Mayberry, Colorado Springs

Filing No. 3

Construction Drawings

MAYBERRY, COLORADO SPRINGS - FILING NO. 3

TYPICAL URBAN LOCAL ROAD SECTION - 60' ROW
 (URBAN LOCAL)
 SCALE: 1"=5' H
 1"=2.5' V

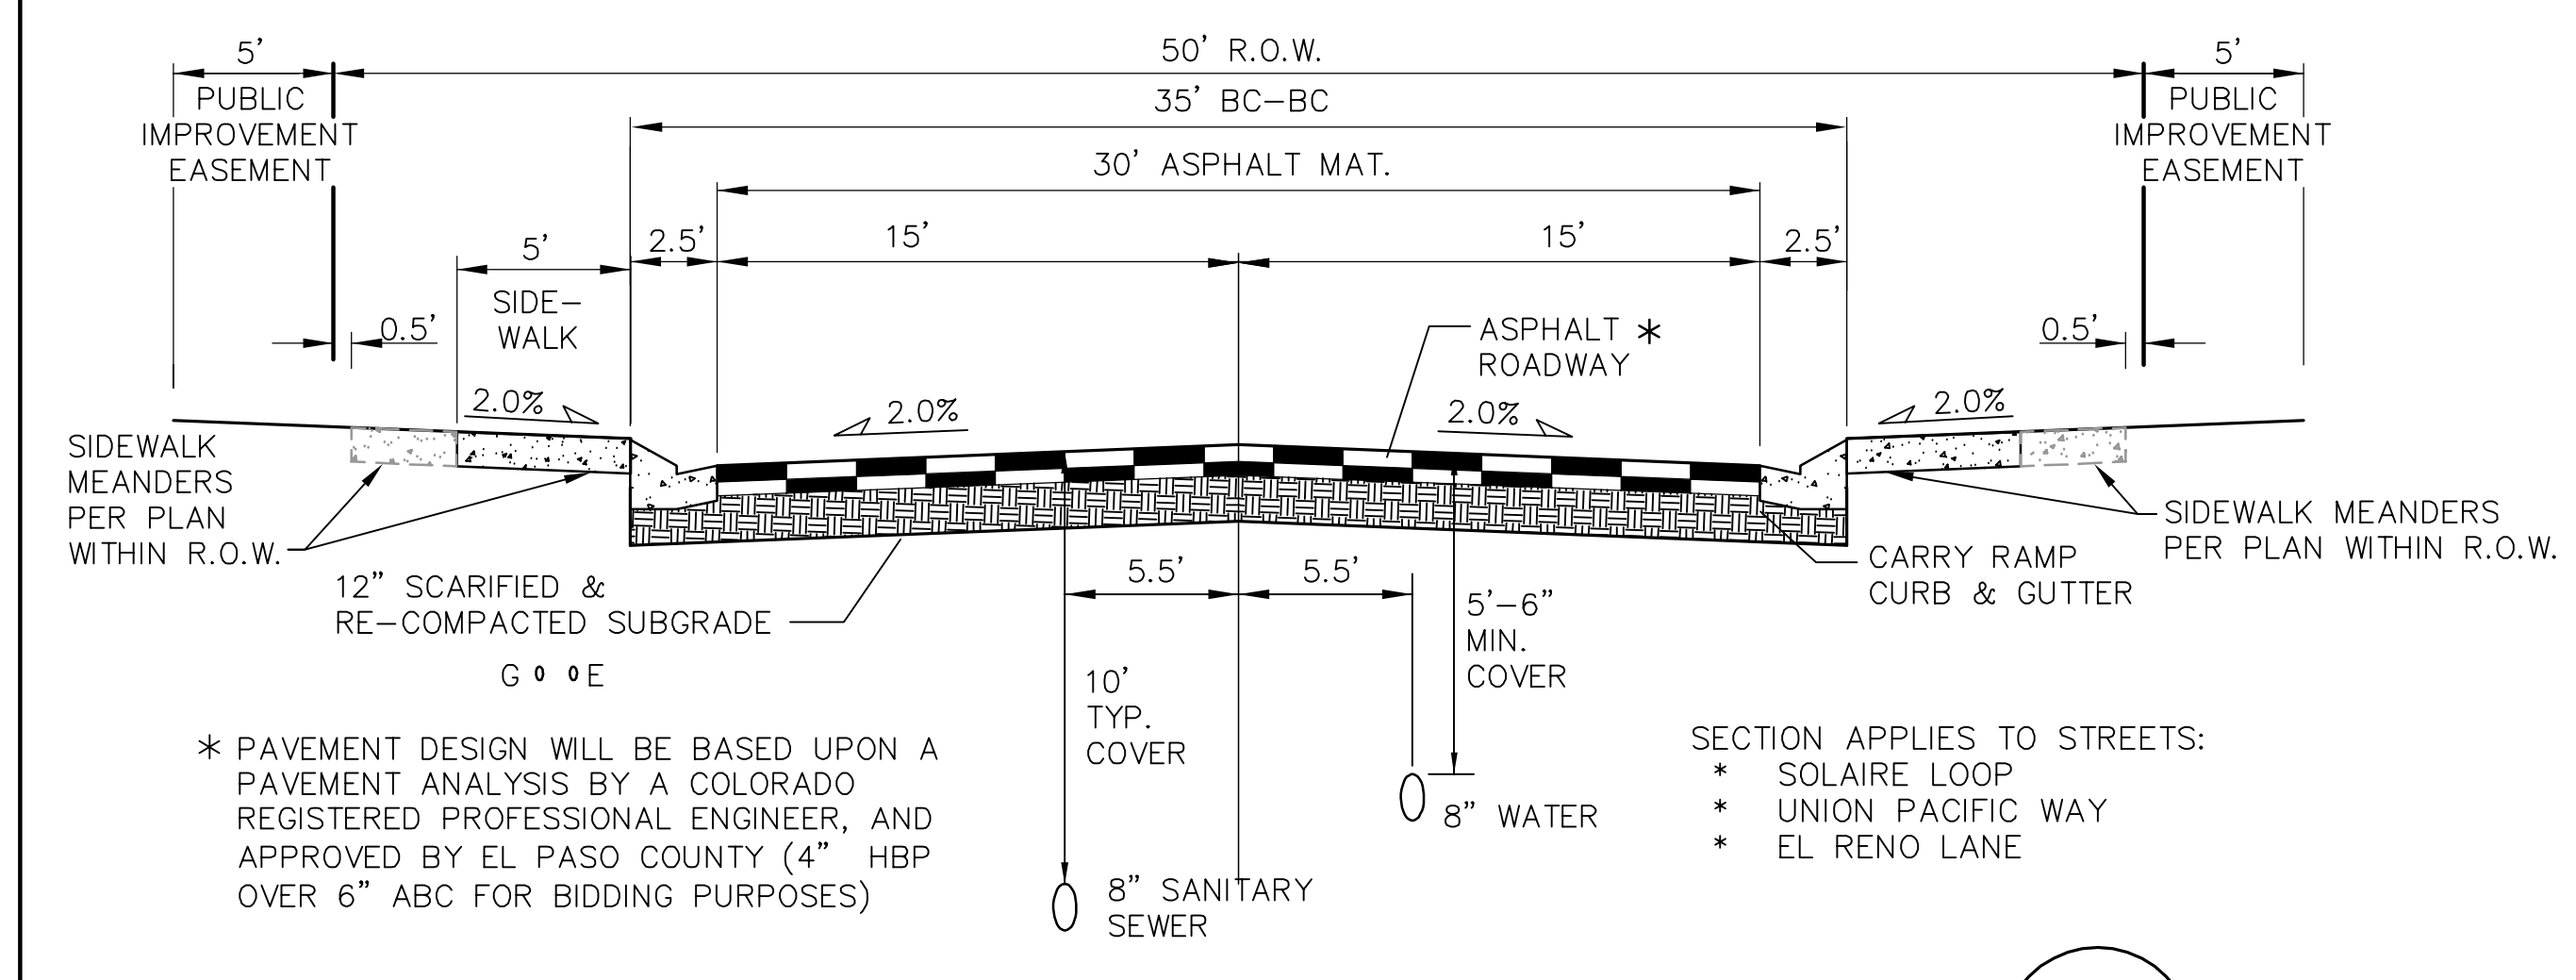
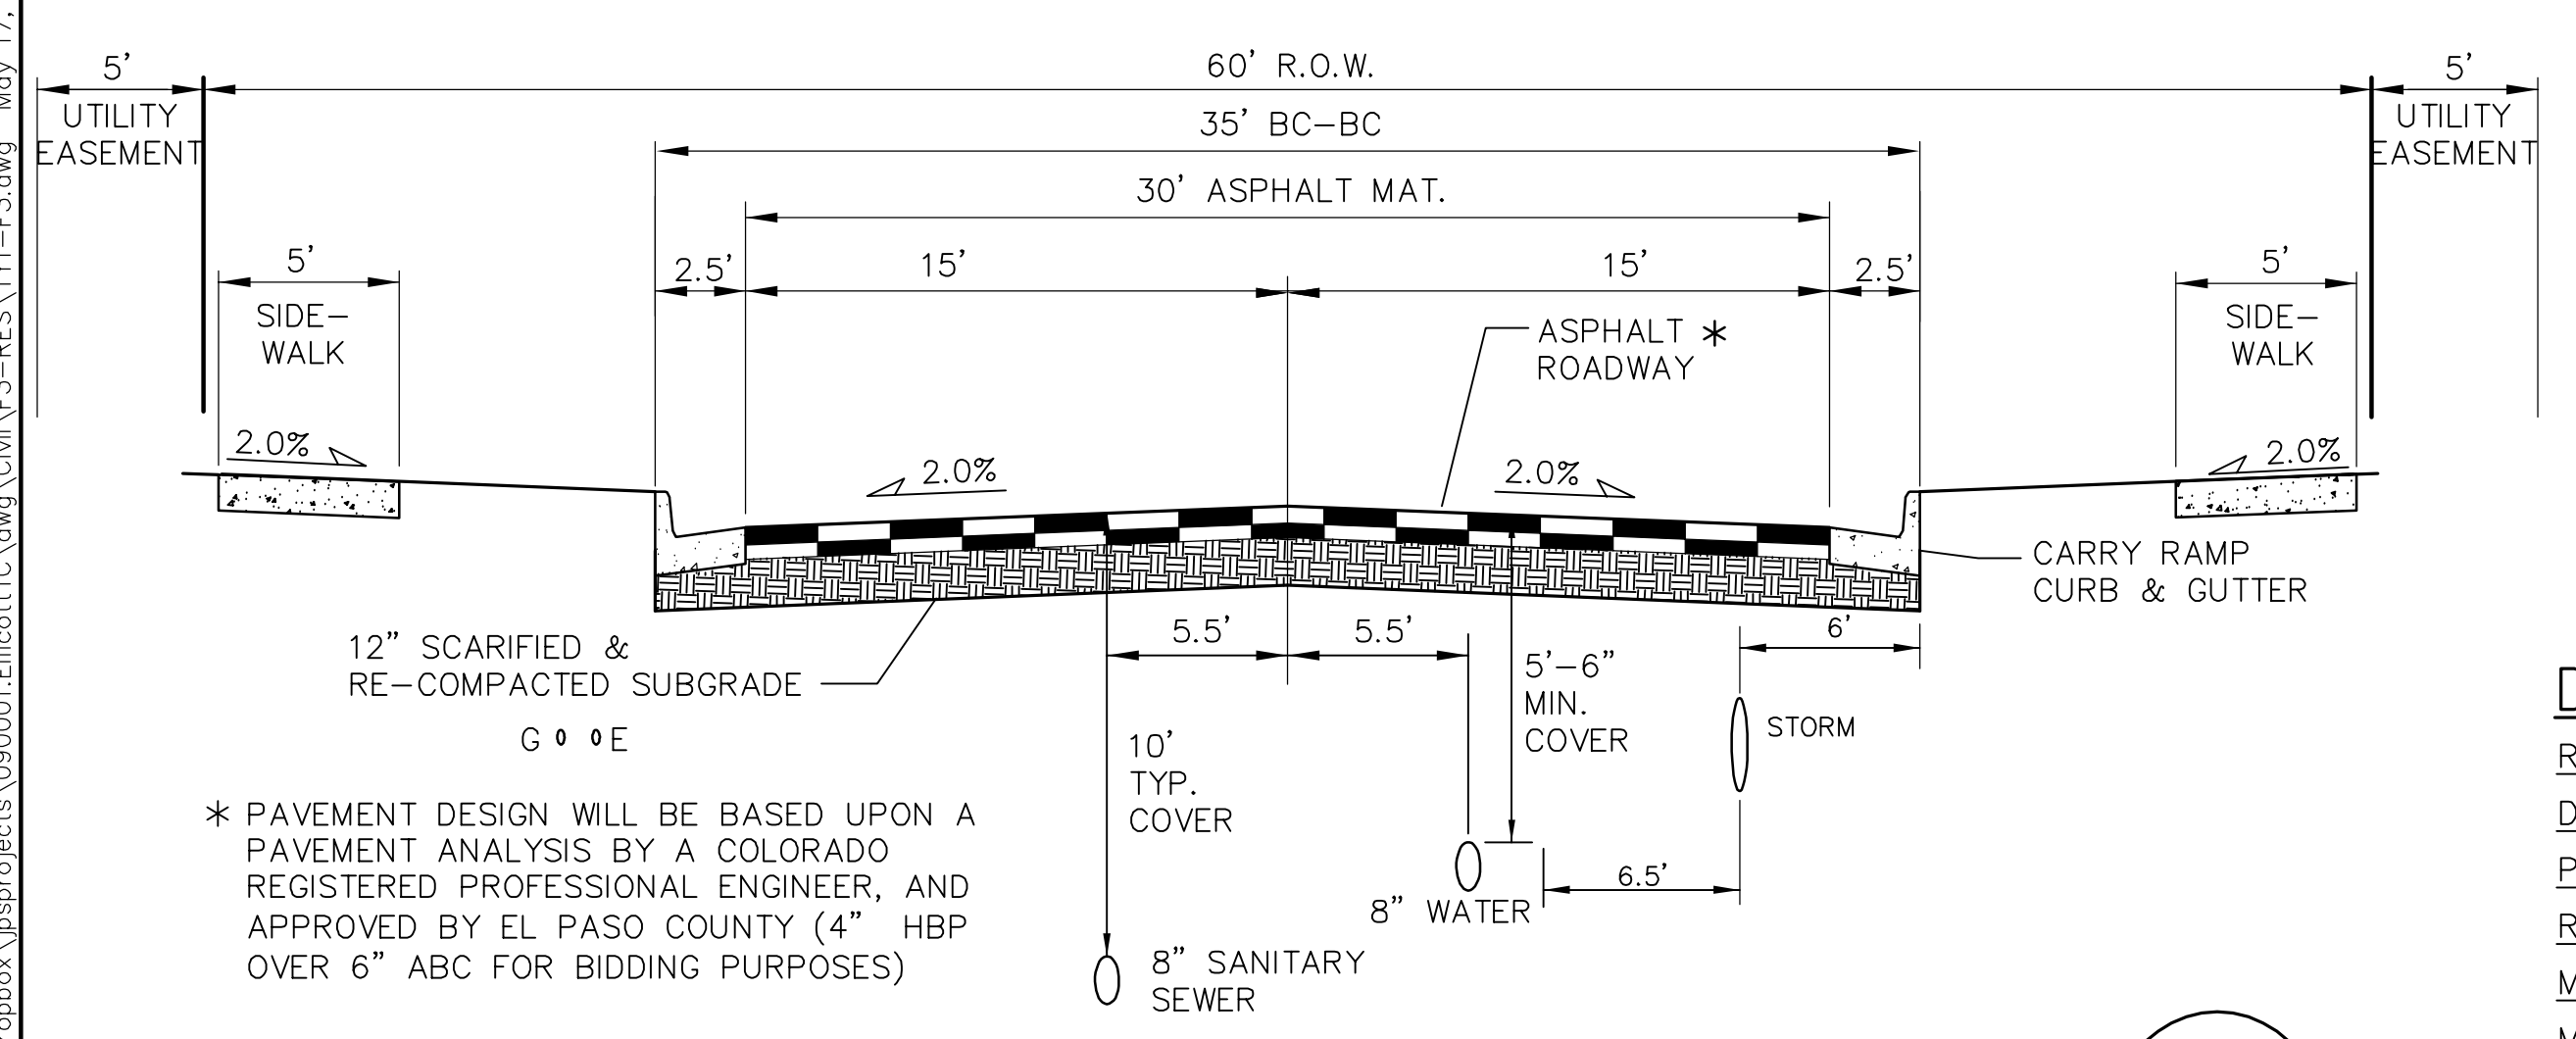
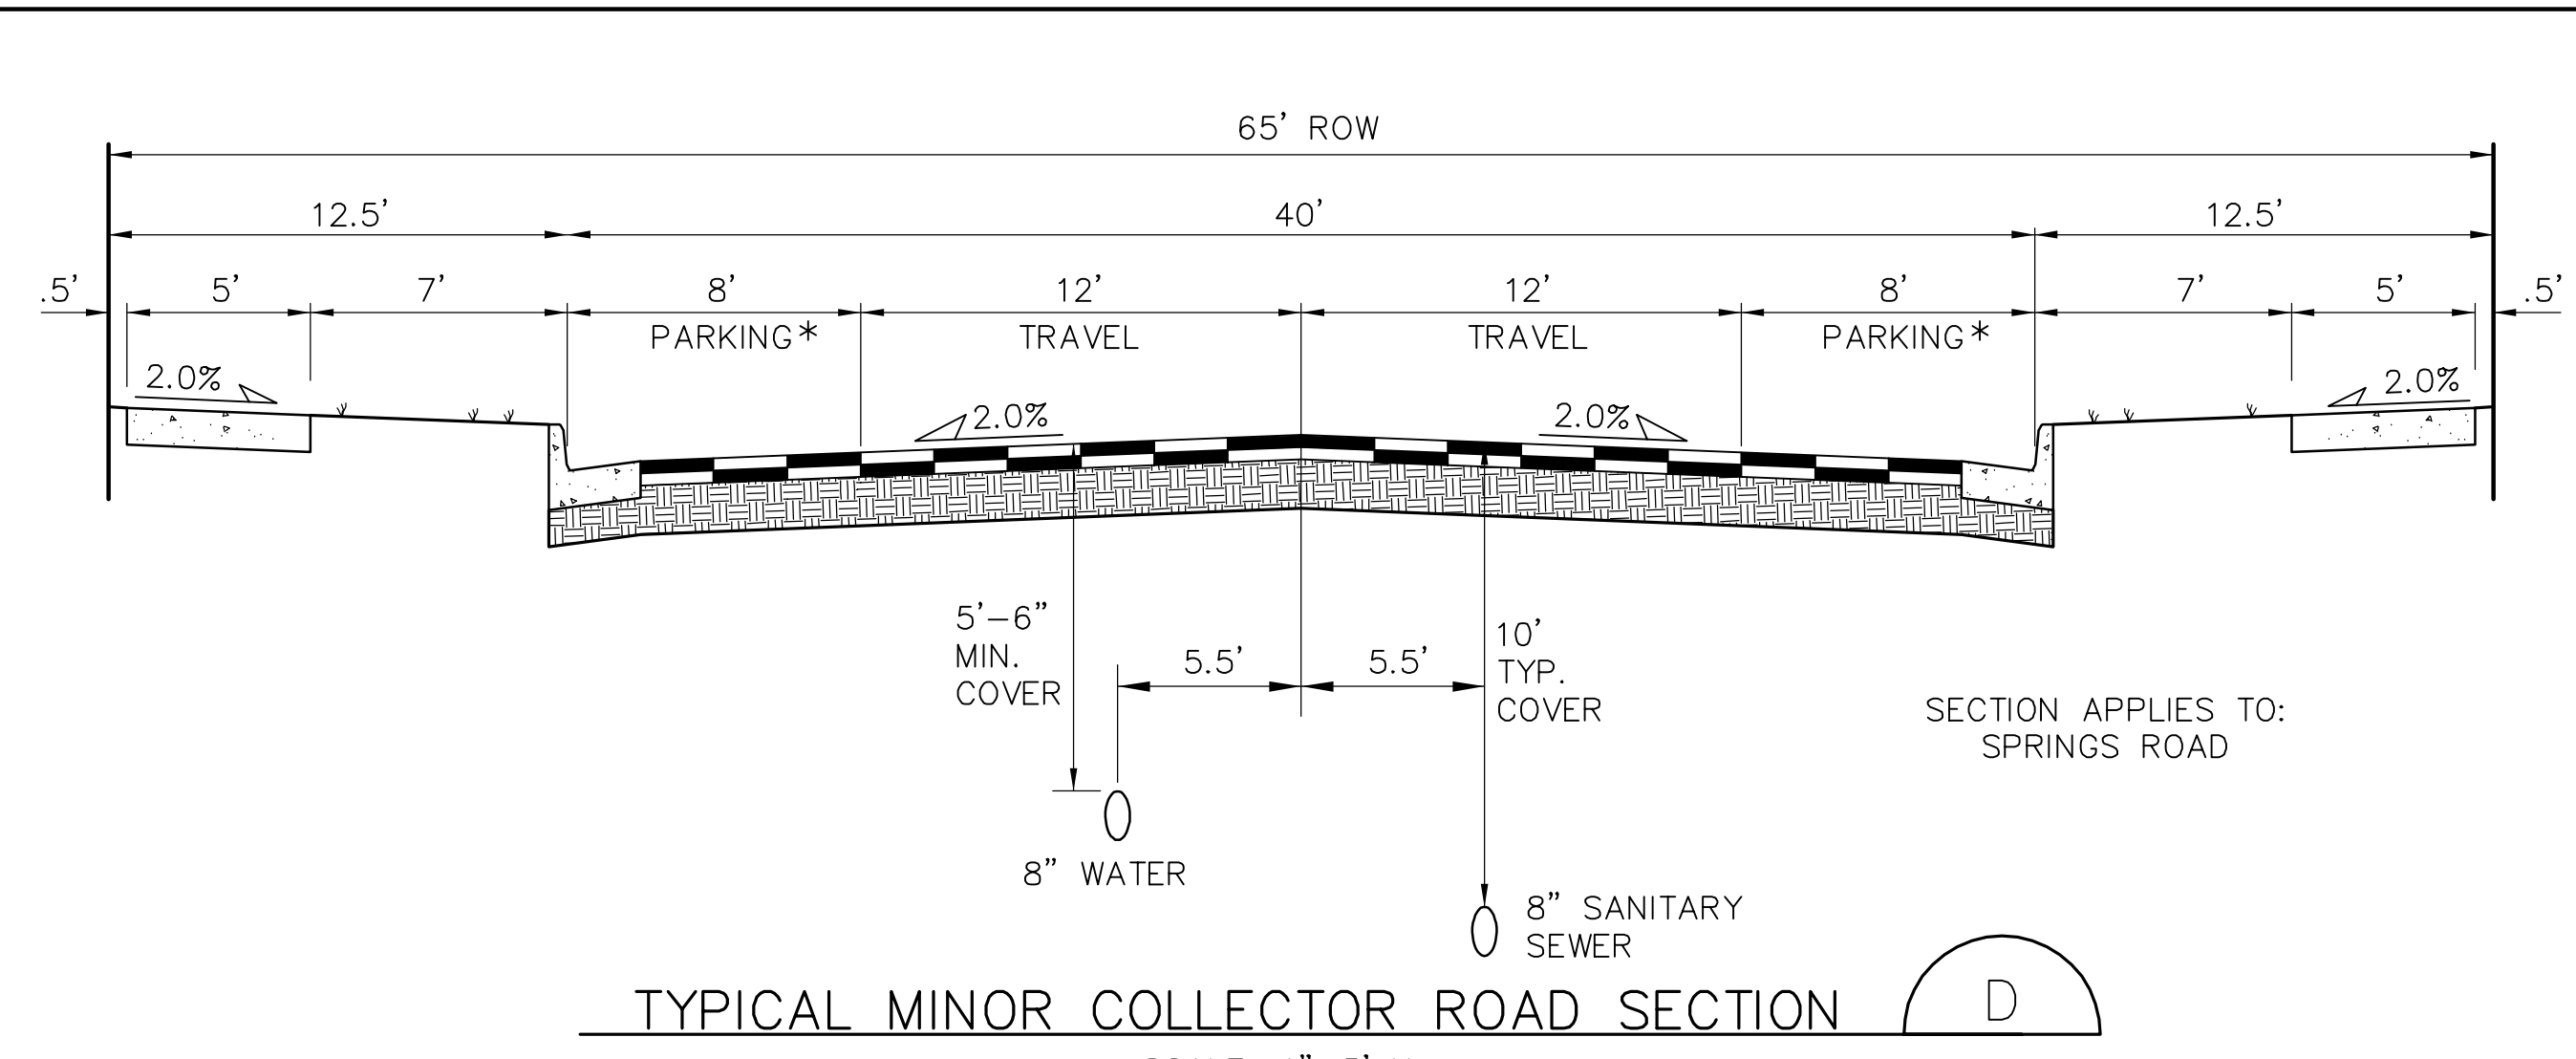
Call out the curb and gutter type that will be used in the cross sections.
